Florida Department of Environmental Protection

RE: WARNING LETTER OF POSSIBLE VIOLATIONS AND NON-COMPLIANCE

**Miami Harbor Phase III Federal Channel Expansion
Permit No. 0305721-001-BI
County: Miami-Dade**

**Field notes on impact assessment in Miami Harbor Phase III Federal Channel
Expansion Permit # 0305721-001-BI**

Figure 1. Dive sites for the impact assessment.

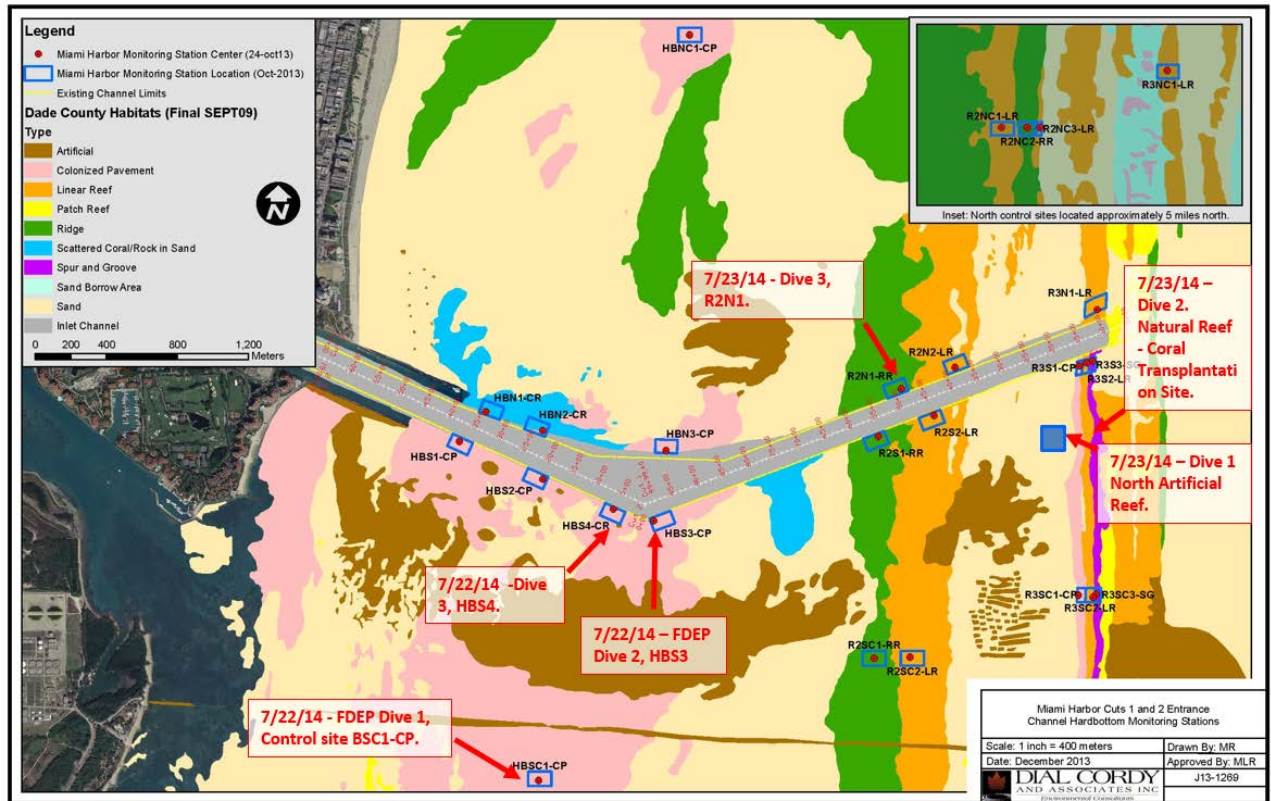
DEP BMES and BIP staff conducted site visits based on the review of the weekly monitoring reports, which included coral stress data that indicated continuous elevated stress on scleractinian corals. Corals were used as organisms-indicators in the during-construction monitoring (Figure 1). Stress was related to increased sedimentation according to observations of monitoring crews (DCA&A as the monitoring team for the project, and independent monitoring observations of Miami-Dade County DERM). The DEP team used visual qualitative observations along 200m transects plotted from the monitoring stations in a north-south direction away from the channel. In addition, sediment depth measurements were taken at 1 m intervals along four of the five transects surveyed by the DEP team (Table 1).

Figure 2. Monitoring station layout. DEP 200 m assessment transects initiated from one of 20 m monitoring transects.

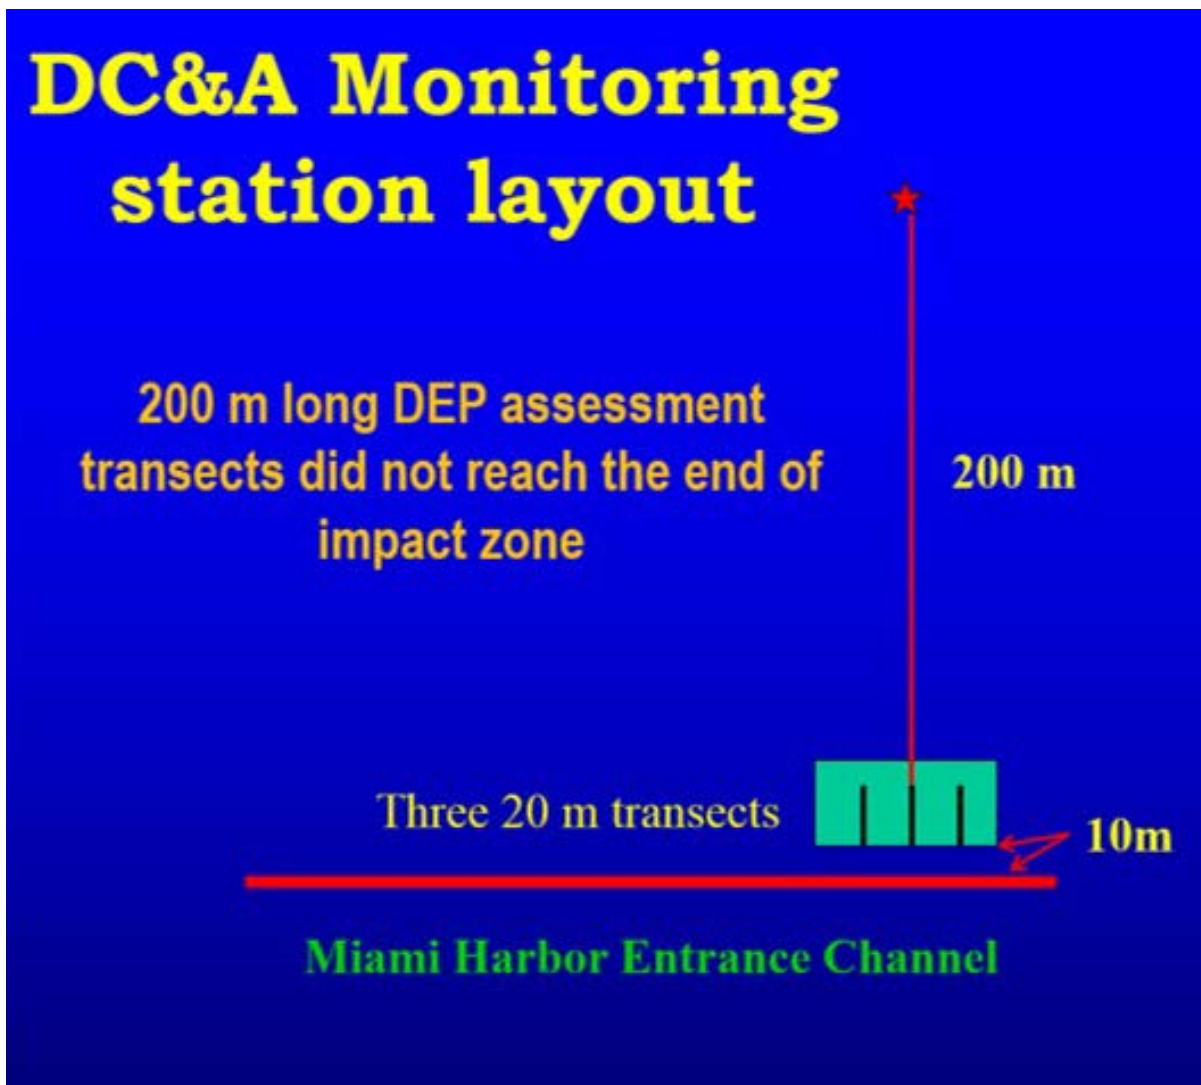
The monitoring protocol for the Miami Harbor project was not designed to document possible impacts beyond the monitoring stations, which are located adjacent to the channel (10 m off the channel) and extended 20 m (Figure 2). However, according DEP Permit No. 0305721-001-BI, Specific Condition 32.a.ii.d, provides that “stress expressed

Figure 3. Landscape in Control Site HBSC1-CP. Low sediment cover, mostly accumulated in small pits. However, some cover of fine sediments exists; development of cyanobacterial mats seems to be related to this slight fine sediment cover.

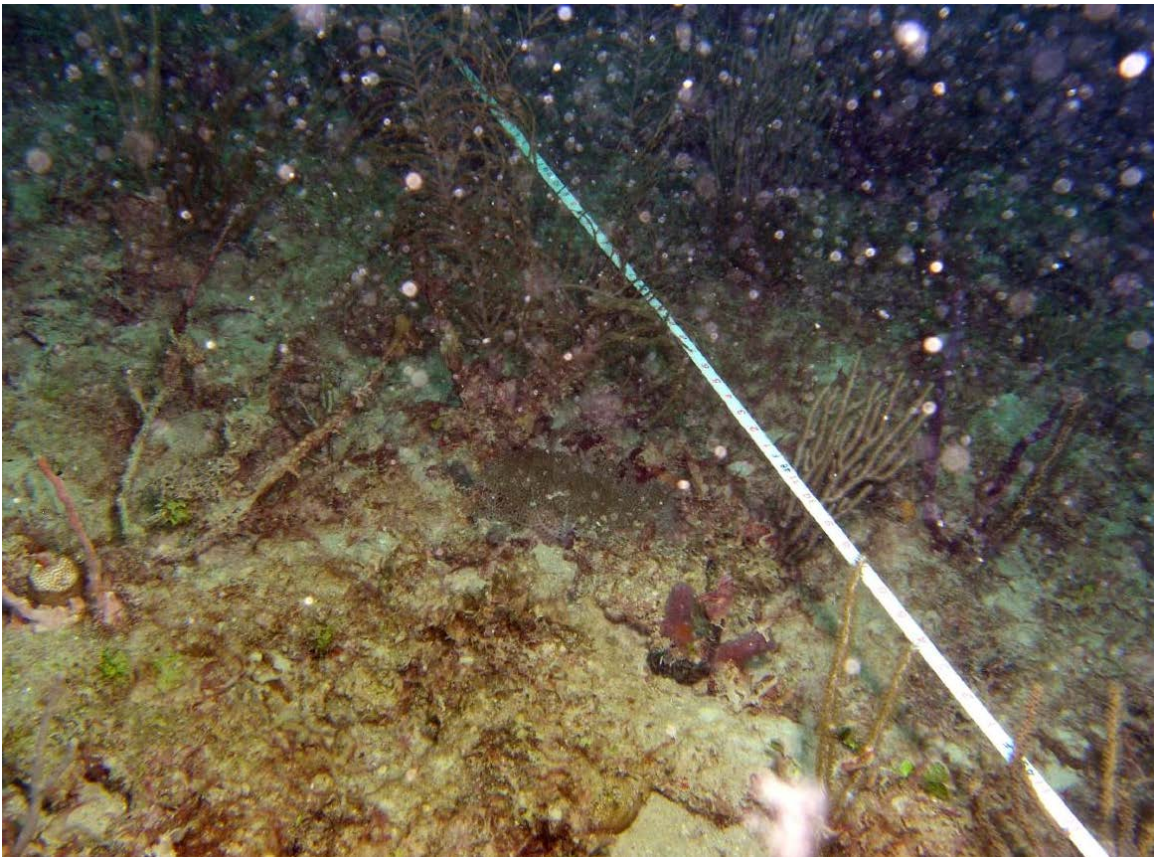
Water depth at the beginning of transect was 6.6m. Landscape: low relief hardbottom (10 cm - 20 cm amplitude of relief), octocoral-sponge-macroalgal community with scattered scleractinian corals (Figure 3). Octocorals often form small groups and colonies can be up to 1m tall. The majority of the substrate was exposed hardbottom, a small percent of the substrate was small pits filled with 1-2 cm of sediments. Sediments within these pits are mostly sand, however some finer sediments were present. Fine sediments did not form a continuous cover, but these fine sediments had dusted over entire hardbottom and benthos. Fine sediments were mixed with sand only at the very surface of sand in small sediment patches, indicating that they were recently deposited. Measurements of

Figure 12. Over 50% of this *Gorgonia ventalina* colony (background) was dead due to sediment accumulation. The sponge *Ptilocaulis walpersii* (front) was also impacted.

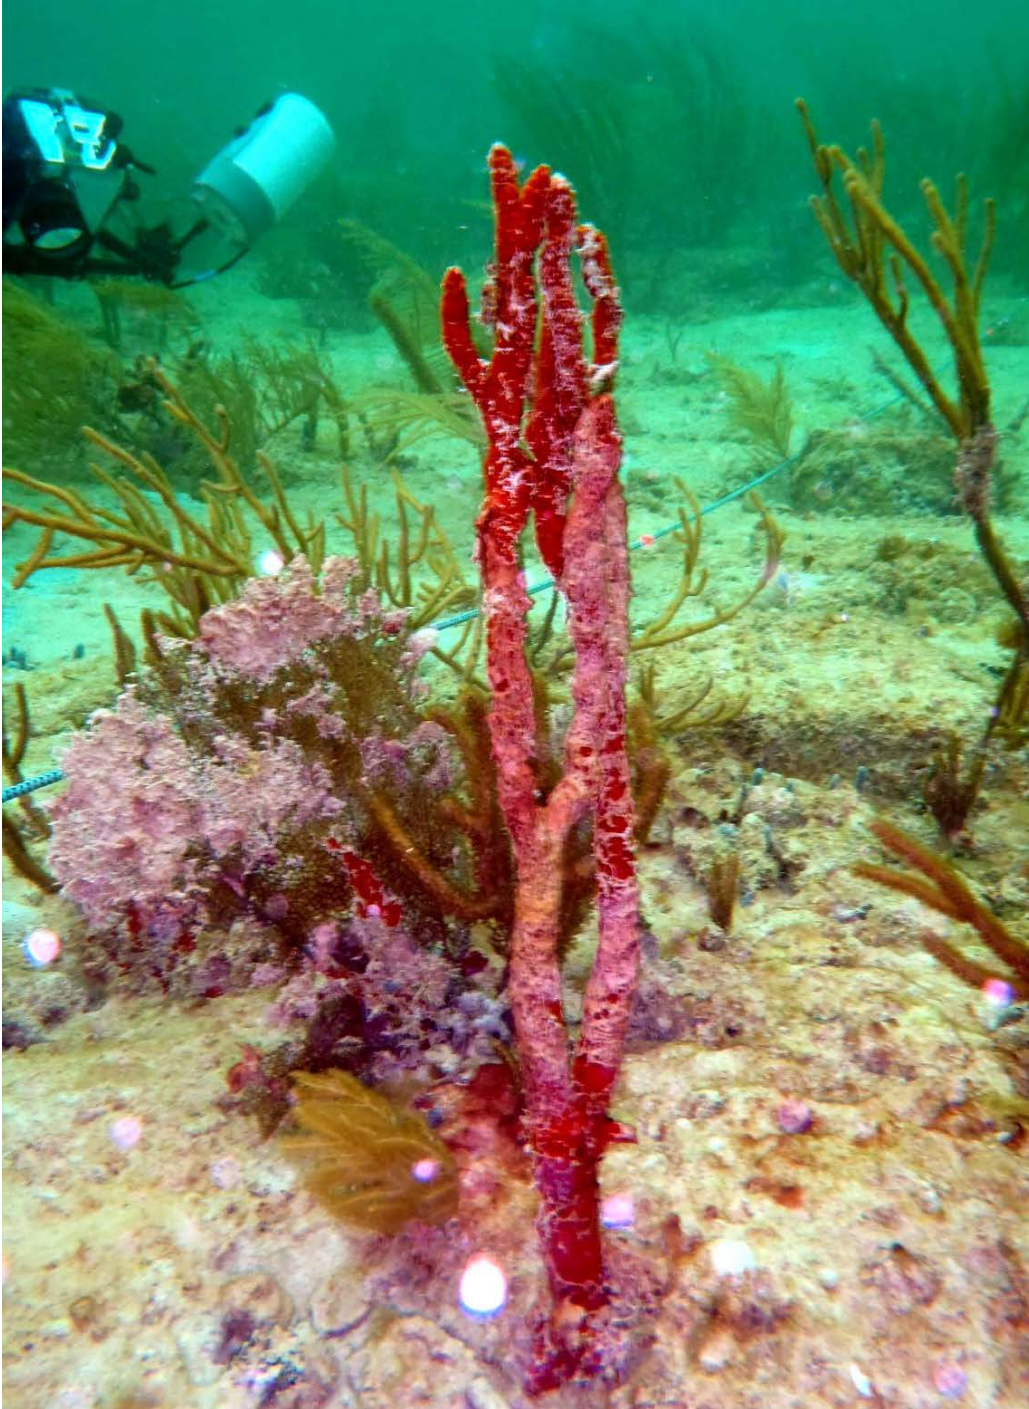
Water depth was 7.6m at the beginning of the transect. The transect stretched along one of the monitoring transects and extended farther southward; observations and measurements along the transect continued over 100 m along the transect. Landscape: low relief hardbottom – relatively flat, with some scattered bumps and rocks (20-40 cm amplitude of relief), formed by previous coral growth; octocoral-sponge dominated community with scattered scleractinian corals. Microrelief of hardbottom was obscured by 1 - 5 cm thick layer of fine sediments, according to measurements around coral and octocoral colonies (Figure 8). Visually and by hand-test sediments are silt and clay. Within less than 1 cm from the surface, the sediments become anoxic (Figure 9). Most small (< 10 cm) scleractinian corals were influenced by sedimentation with stress levels ranging from 3 to 4. Larger colonies (> 10 cm) were able to shed sediments down to the base of colony, however, as a result, this material covered the base of the colony and often resulted in partial mortality, i.e., forms dead fringe up to 7-12 cm wide depending on the morphology of corals (Figures 10 and 11). Very few juvenile scleractinian corals were observed, located only on higher relief hardbottom, and no recruits < 3 cm size were observed due to the cover of substrate by sediments. Practically all octocorals, excluding very few growing on highest parts of hardbottom, have holdfasts covered by sediments; all juvenile octocorals were partially buried. Sea fans *Gorgonia ventalina* were often covered with sediments and cyanobacterial mats had developed on those sediments (Figure 12). *Gorgonia ventalina* normally prefer clear water, and the current situation of high sedimentation is obviously not common for this habitat. Sediment cover over hardbottom was documented up-to the 100 m transect mark; moreover, sediment cover continued at least within the distance of visibility beyond that point.

Figure 12. Landscape along the transect south of compliance station HBS3. Sediment accumulation was continuous along transect and was measured every meter.

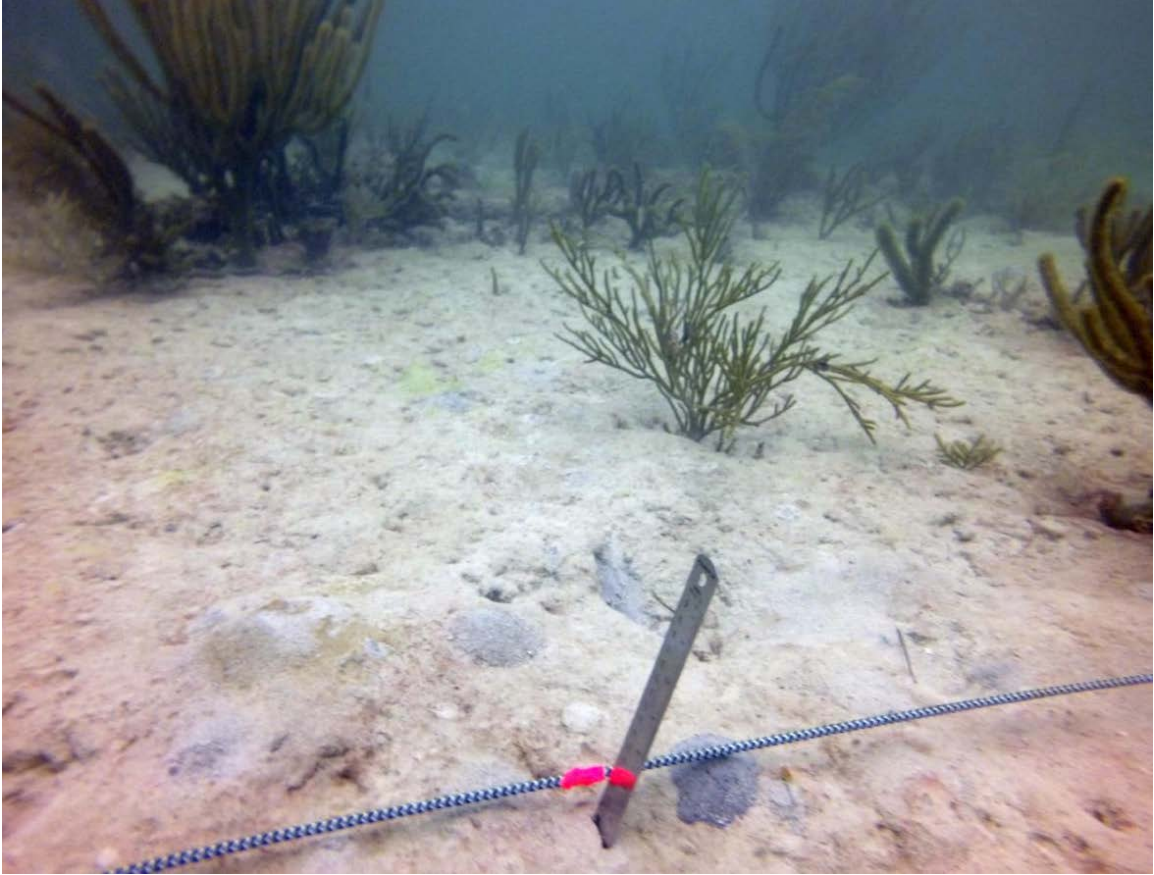
was very similar to the site assessed southward of HBS3 and was uniform through the entire length of the transect (Figure 12). The hardbottom was low relief, seldom more than 10-15 cm in amplitude, excluding very few larger rocks with relief of 30-40 cm noticed closer to the end of the transect. Around 100 m a rubble field was observed on the western side of the transect (Figure 13). Tall octocorals dominated the community (octocoral-sponge-scleractinian community). Macroalgae were only observed in sparse higher relief areas; macroalgae in lower-relief areas had been buried. Cyanobacterial mats were widespread on sediment layer over substrate and benthic organisms. Thickness of fine sediments, according to measurements around coral and octocoral colonies is 1 cm to 5 cm (Figures 14 and 15). Sediments were silt and clay, with possible small part of very fine sand closer to the channel. Measurements of sediment thickness along the transect (1 m interval sediment depth measurements) demonstrated variable cover between 0.5 cm and 14 cm, with average (\pm sd) of 3.8 ± 2.98 cm (Table 1). Most of small (< 10 cm) scleractinian corals (of survived) had elevated levels of sedimentation stress, at the level of 3-4. Even large colonies, which were able to shed sediments down to the base of colony, often have dead fringe around them up to 7-12 cm depending on the morphology of corals (Figures and). Very few juvenile scleractinian corals were observed, located only on higher relief hardbottom, and no recruits were observed due to sediment cover over hardbottom. Practically all octocorals, excluding very few growing on highest parts of hardbottom, have holdfasts covered by sediments; all juvenile octocorals are partially buried (Figure 14). Sea fans *Gorgonia ventalina* were affected by sediments and by cyanobacterial mats that developed on these sediments. Sediment cover over hardbottom was traced to the transect mark 105 m and at that point it was continued at least within the distance of visibility beyond that point.

Figure 20. Patch of hardbottom with boulder placed over it.

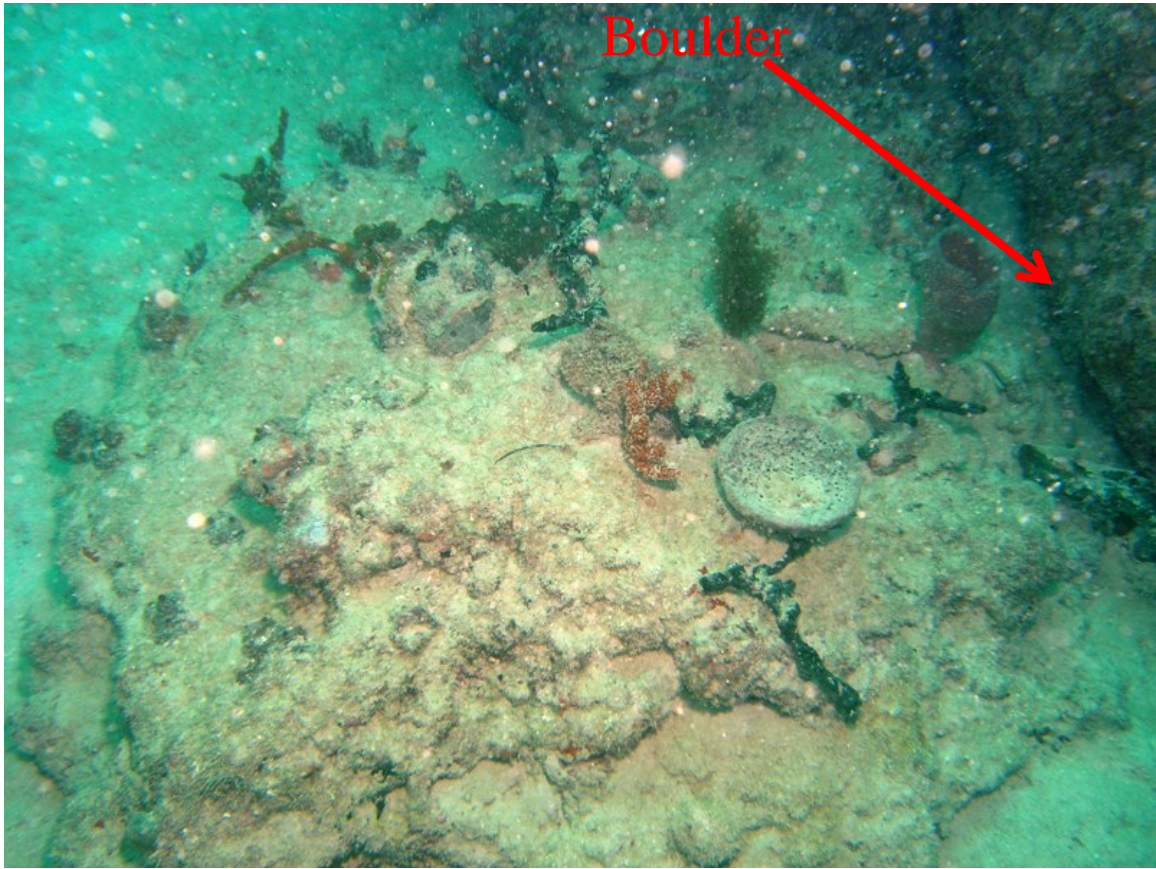
Dive 1, North Mitigation Reef. The inspection of the Northern Mitigation Reef was done in order to compare this site with a nearby transplantation site on the natural Outer Reef, where sedimentation was previously observed by DERM. This dive was very brief and only a small portion of the artificial reef was observed; yet, several patches of natural hardbottom were observed. Patches of hardbottom contained well-developed communities with scleractinian corals, octocorals, sponges, algae, etc. These natural hardbottom areas had been impacted by the placement of boulders; the types of impacts varied from direct impacts by boulders to hardbottom substratum and benthos, to burial of benthic fauna and flora by displaced sediments or sedimentation over them in the areas where boulders were dropped adjacent to hardbottom patches. Fragmented corals, damaged sponges and octocorals were seen in several patches (Figures 17-22).

During the Department’s site inspection, impacts were also documented at the mitigation reef site. Boulder placement at the site had damaged natural hardbottom resources and violated specific condition 33. A fast response to this issue may minimize long-lasting impacts.

- Damaged corals and octocorals should be transplanted as soon as possible to prevent mortality. The extent of the impacts to natural hardbottom in the area of mitigation reef should be surveyed, and the results of this survey should be provided to the Department. The results of this survey shall be evaluated by the Department to determine if additional mitigation is necessary. Department staff are available to provide assistance in the preparation of monitoring and transplantation protocols.

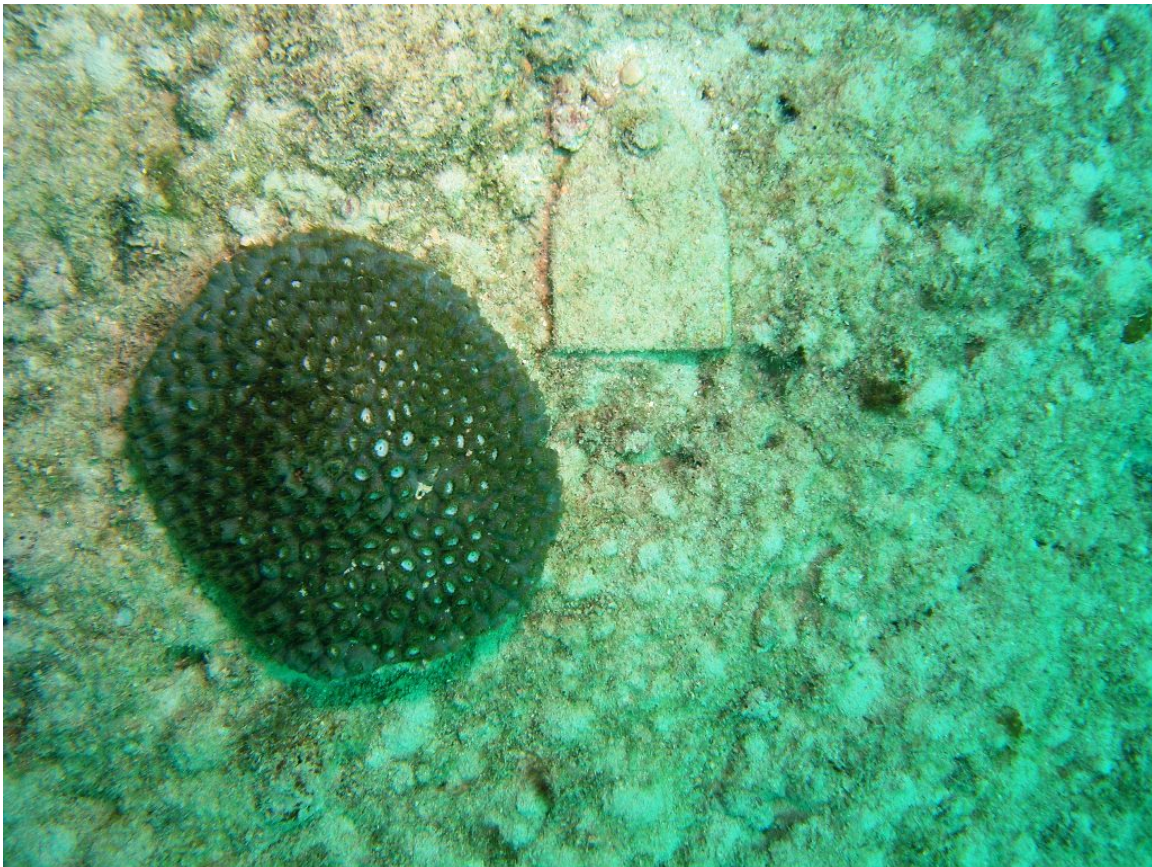
covered with fine sediments (Figures 23 and 24); however, the cover was not continuous or sheet-like as was observed in stations HBS3 and HBS4. Fine sediments covered the substrate and benthos; however, sandy sediments were found in pits and channels, where fine sediments had formed a thin top layer; this observation suggests that fine sediments have accumulated recently and are not as common for this area as sandy sediments. The effect of sedimentation on corals was variable, ranging from a level of 1 to 3, depending on the microhabitat (i.e., relief) where coral is growing. Some colonies were considerably affected by sedimentation (Figure 25), while others had a relatively small effect (Figure 24). Fine sediments had accumulated along the entire transect, and sediments visually increased toward the channel. Overall the effect of sedimentation was considerably lower than at the compliance stations HBS3 and HBS4.
